QUAD CITIES UNIT 1

AMENDMENT TO FACILITY OPERATING LICENSE

Amendment No. 25
License No. DPR-29

ATTACHMENT TO LICENSE AMENDMENT NO. 25

PLANAR AVERAGE EXPOSURE (MWD/T)
FIGURE 3.5.1

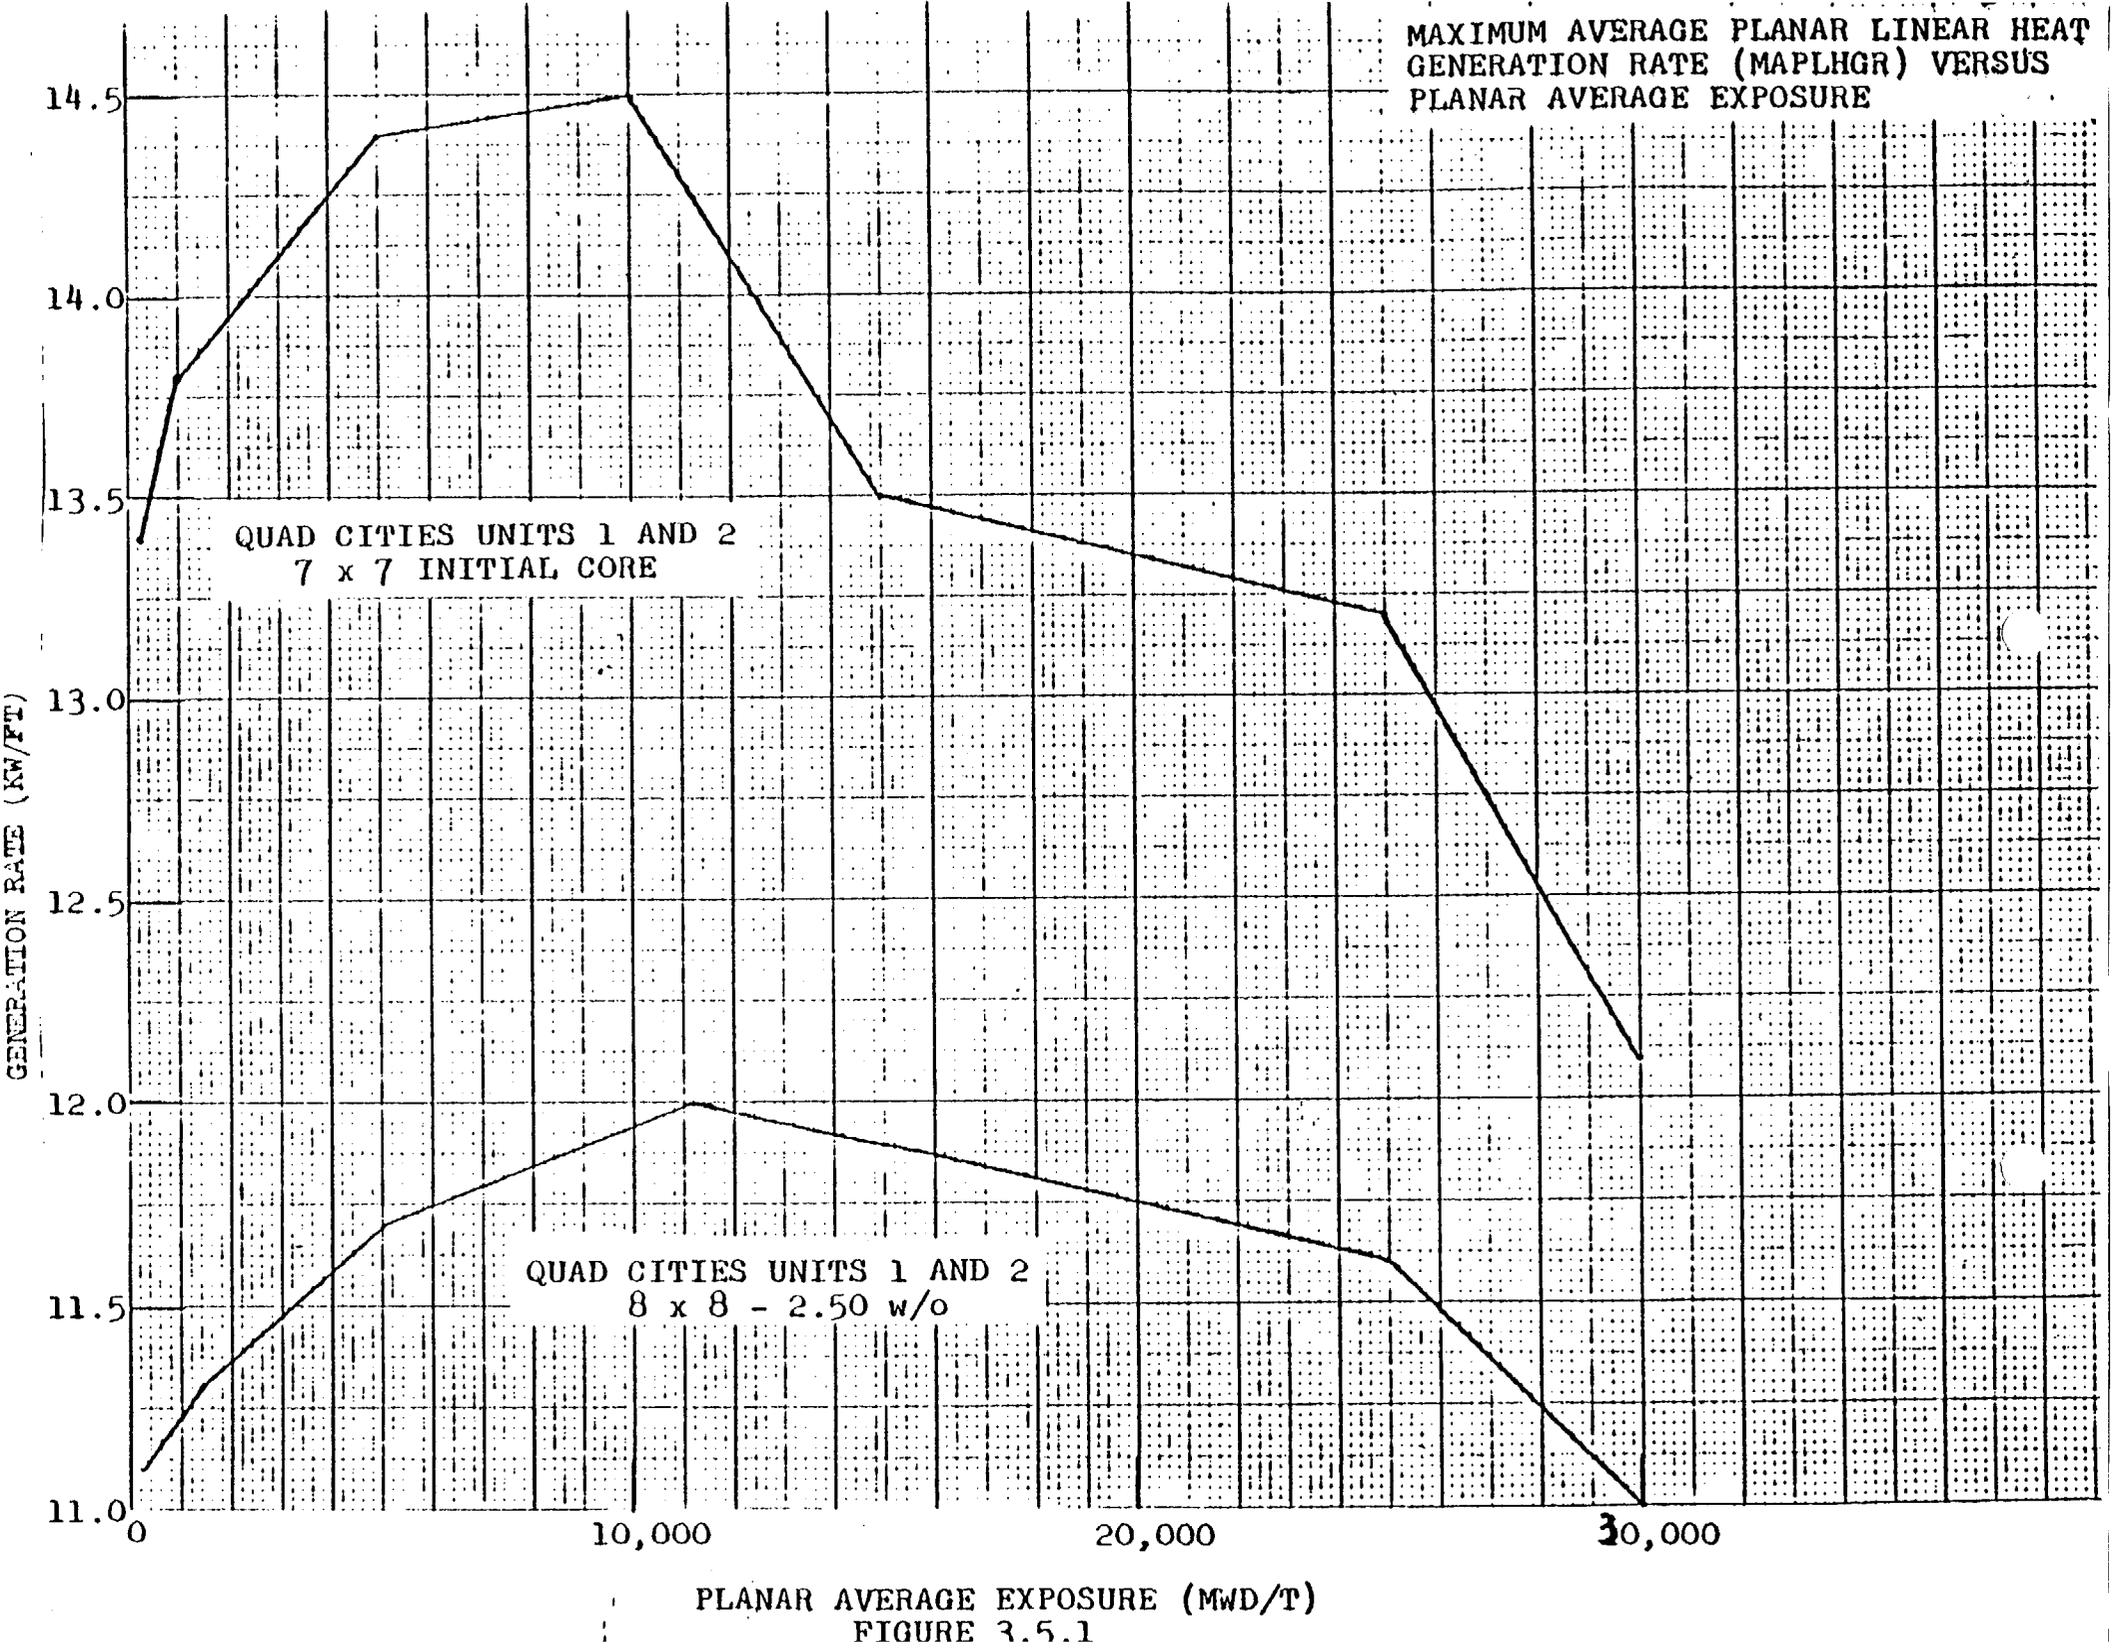
During steady state power operation, the average linear heat generation rate (LHGR) of all the rods in any fuel assembly, as a function of average planar exposure, at any axial location, shall not exceed the maximum average planar LHGR shown in Figure 3.5.1 and 3.5.1A.

During steady state power operation, the average planar linear heat generation rate (APLHGR) of all the rods in any fuel assembly, as a function of average planar exposure, at any axial location, shall not exceed the maximum average planar LHGR shown in Figures 3.5.1, 3.5.1A and 3.5.1B. If at any time during operation it is determined by normal surveillance that the limiting value for APLHGR is being exceeded, action shall be initiated within 15 minutes to restore operation to within the prescribed limits. If the APLHGR is not returned to within the prescribed limits within two (2) hours, the reactor shall be brought to the Cold Shutdown condition within 36 hours. Surveillance and corresponding action shall continue until reactor operation is within the prescribed limits.

PLANAR AVERAGE EXPOSURE (MWD/T)
FIGURE 3.5.1.A

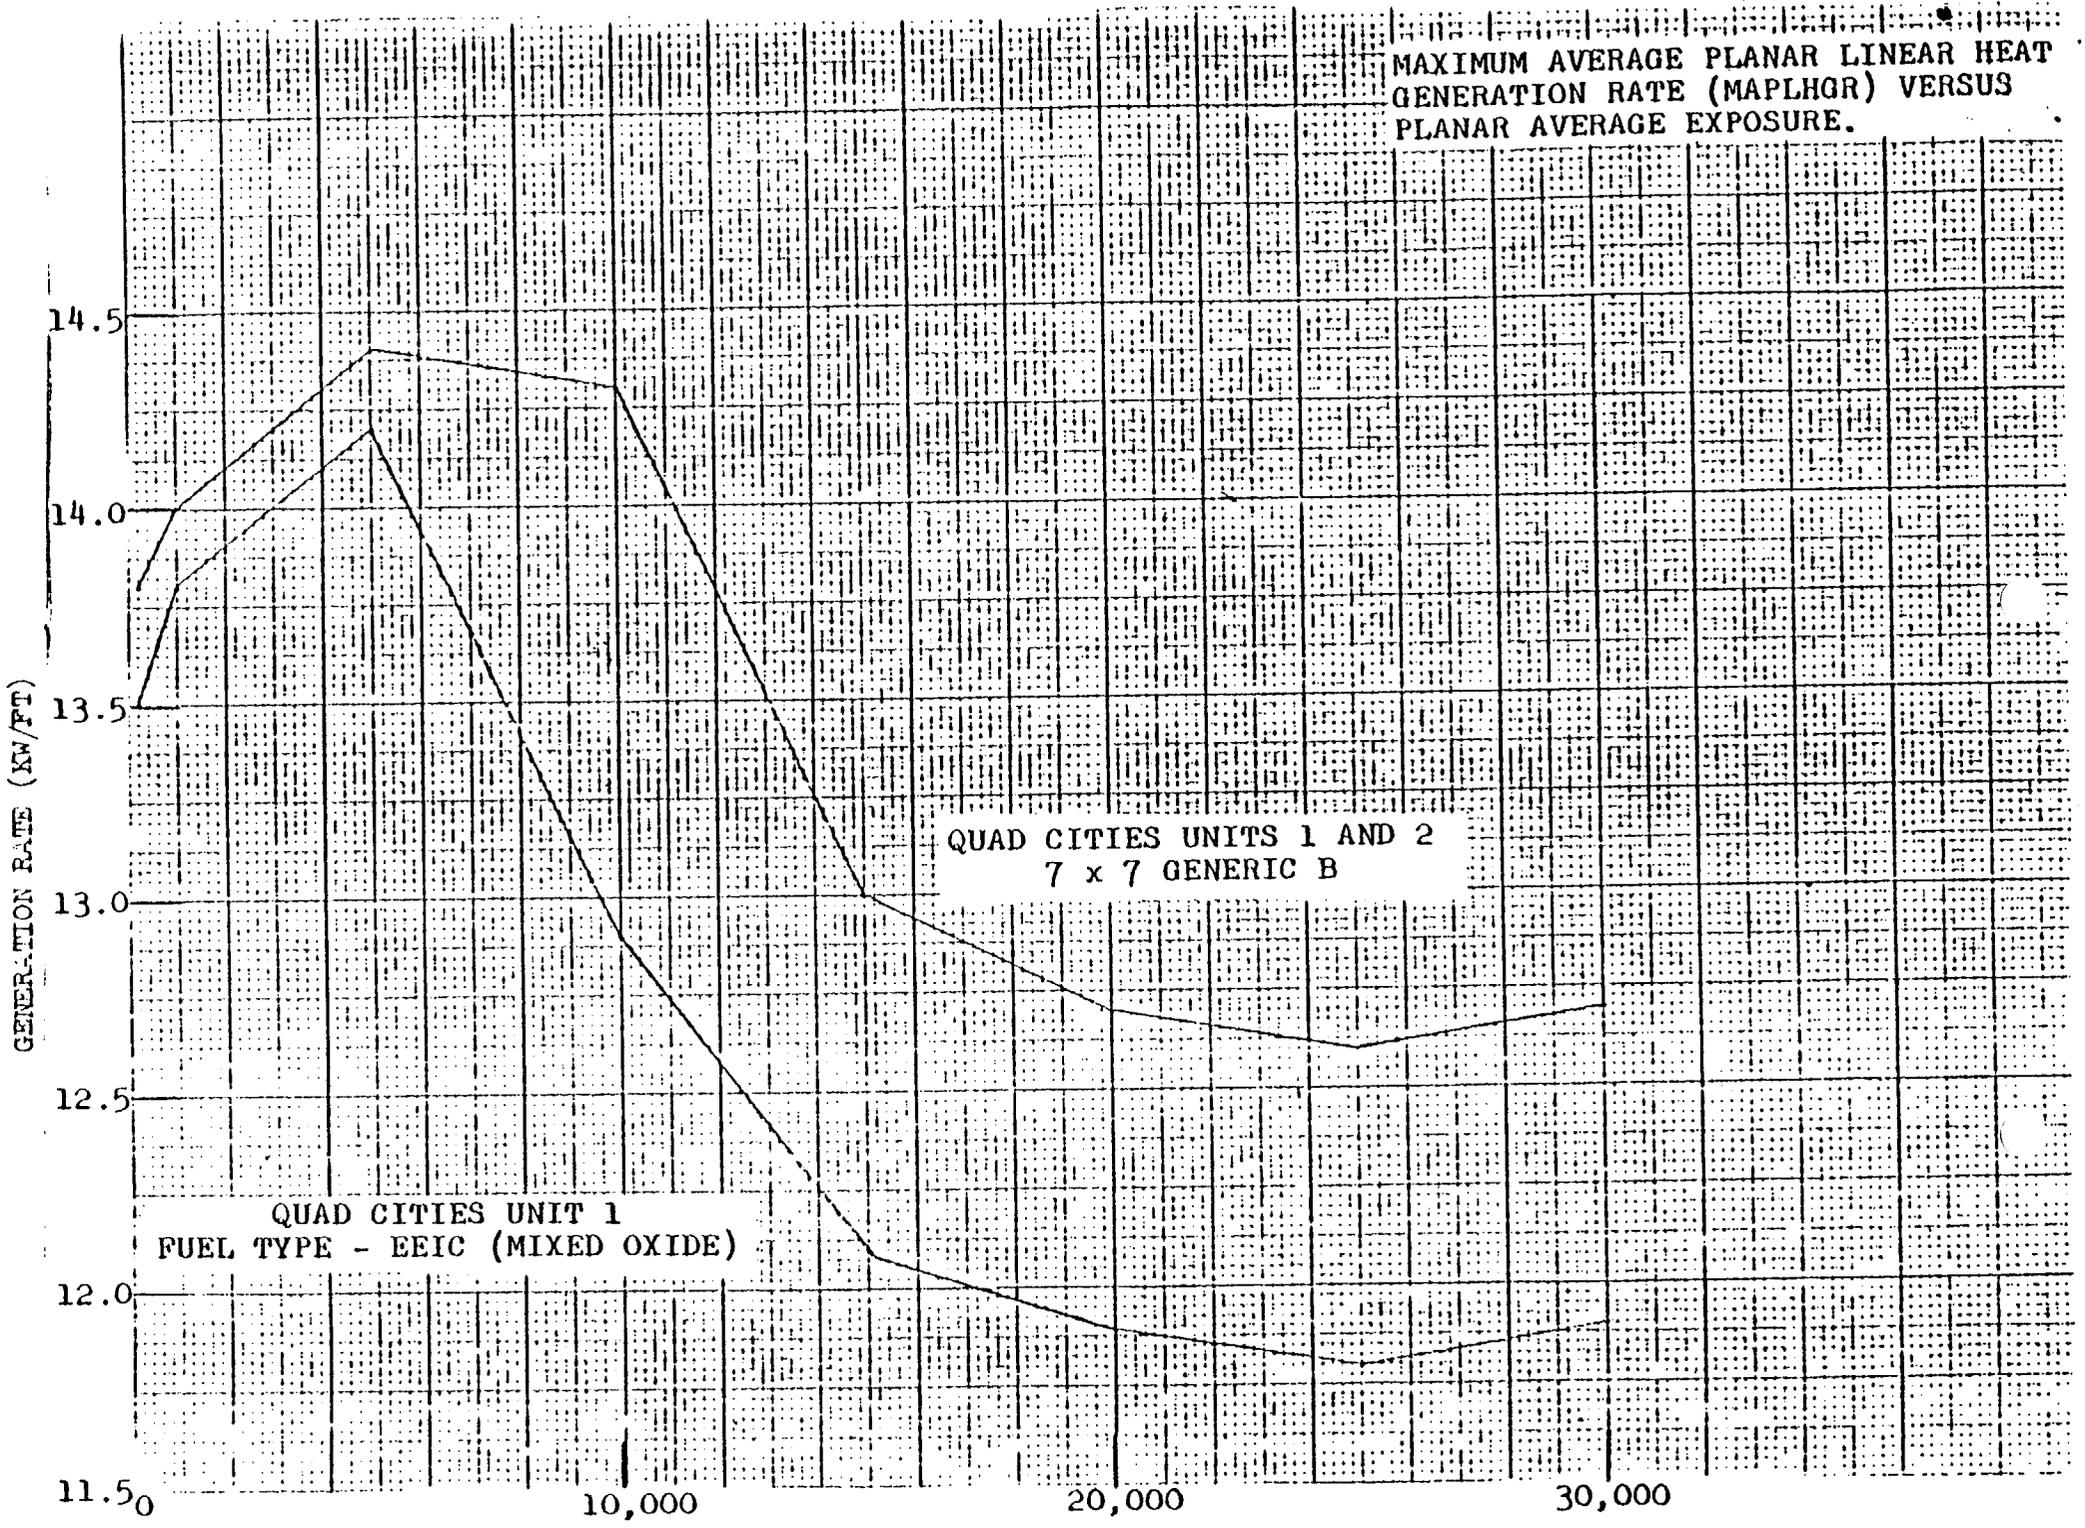
MAXIMUM AVERAGE PLANAR LINEAR HEAT
GENERATION RATE (MAPLHGR) VERSUS
PLANAR AVERAGE EXPOSURE.

QUAD CITIES UNIT 1
FUEL TYPE - EEIC (MIXED OXIDE)

PLANAR AVERAGE EXPOSURE (MWD/T)
FIGURE 3.5.1.B

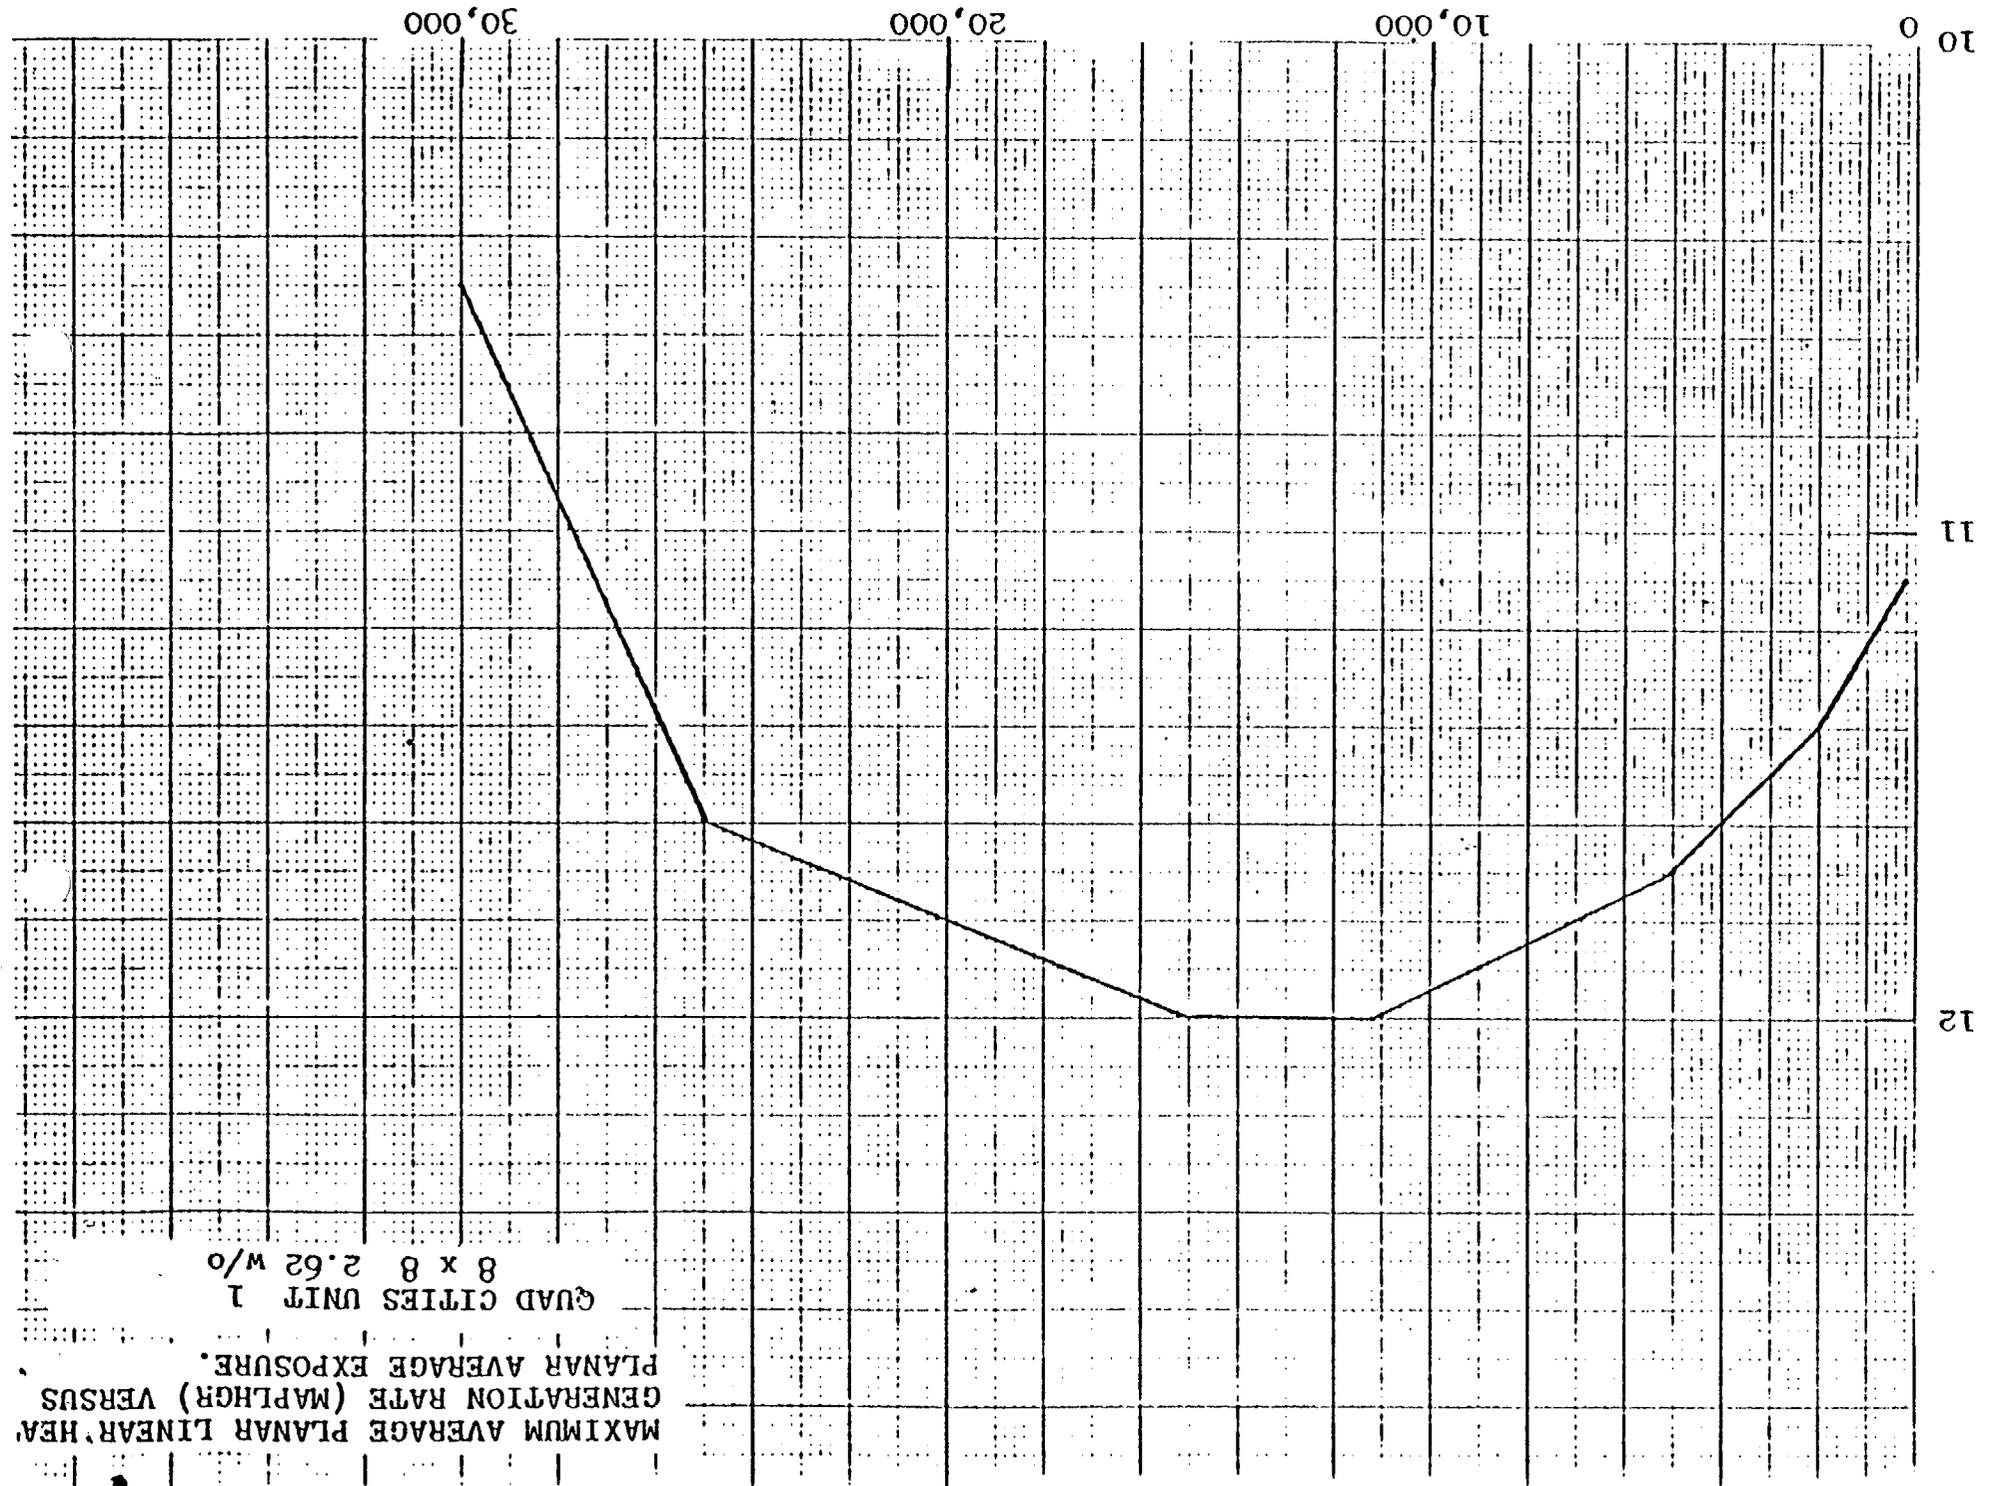
MAXIMUM AVERAGE PLANAR LINEAR HEAR
GENERATION RATE (MAPLHGR) VERSUS
PLANAR AVERAGE EXPOSURE.
QUAD CITIES UNIT 1
8 x 8 2.62 w/o
